# Access Compliance Report

## Public Rights-of-Way

### (Curb Ramps)

Intersection ID: 13149	Main Street: CENTRAL_AV	Cross Street: THE_PLAZA	Location: NE
ADA ID: 88547B7E774F	Ramp Type: Perp	Initial Pass/Fail: Fail	Overall Compliance: No
		Severity Score: 30

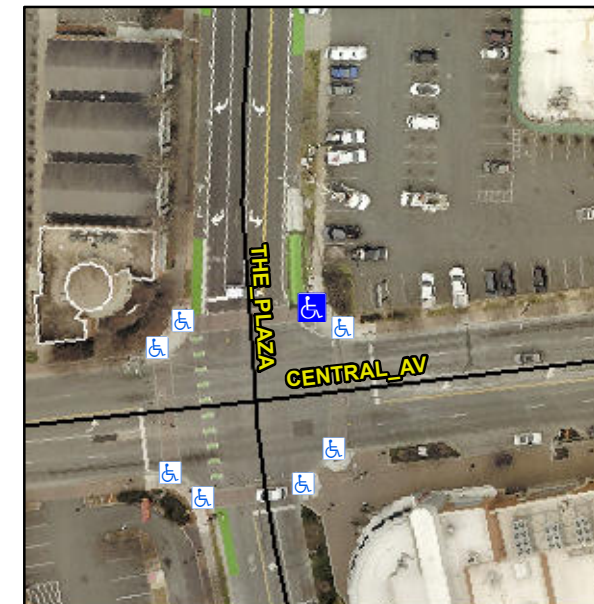
**Not Found, R304.5.1, R304.2.2**

Compliance	Description	Data	Compliance	Description	Data
N/A	Ramp Length (in)	89.0	No	Ramp Slope (%)	10.2
No	Ramp Width (in)	35.5	Yes	Ramp XSlope (%)	1.3
N/A	Flare Type LT	N/A	N/A	Flare Type RT	N/A
N/A	Flare Slope LT (%)	N/A	N/A	Flare Slope RT (%)	N/A
N/A	Flare Traversable LT?	N/A	N/A	Flare Traversable RT?	N/A
N/A	Landing Length (in)	N/A	N/A	DWS Provided?	N/A
N/A	Landing Width (in)	N/A	N/A	DWS Contrast?	N/A
N/A	Landing Slope (%)	N/A	N/A	DWS Length (in)	N/A
N/A	Landing X Slope (%)	N/A	N/A	DWS Full Width?	N/A
N/A	Landing Curb? (Y/N)	N/A	N/A	DWS Offset (in)	N/A
N/A	Shared Landing?	N/A			
N/A	Gutter Ponding?	N/A	N/A	Gutter Slope (%)	N/A
N/A	Gutter Lip Ht (in)	N/A	N/A	Gutter X Slope (%)	N/A
N/A	Painted X Walk1?	Yes	N/A	Painted X Walk2?	N/A
	X Walk 1 Direction	To W		X Walk 2 Direction	N/A
N/A	X Walk 1 Width (in)	96.0	N/A	X Walk 2 Width (in)	N/A
	X Walk 1 Slope (%)	0.5		X Walk 2 Slope (%)	N/A
	X Walk 1 X Slope (%)	0.4		X Walk 2 X Slope (%)	N/A

**Remove & Replace Entire Ramp.**
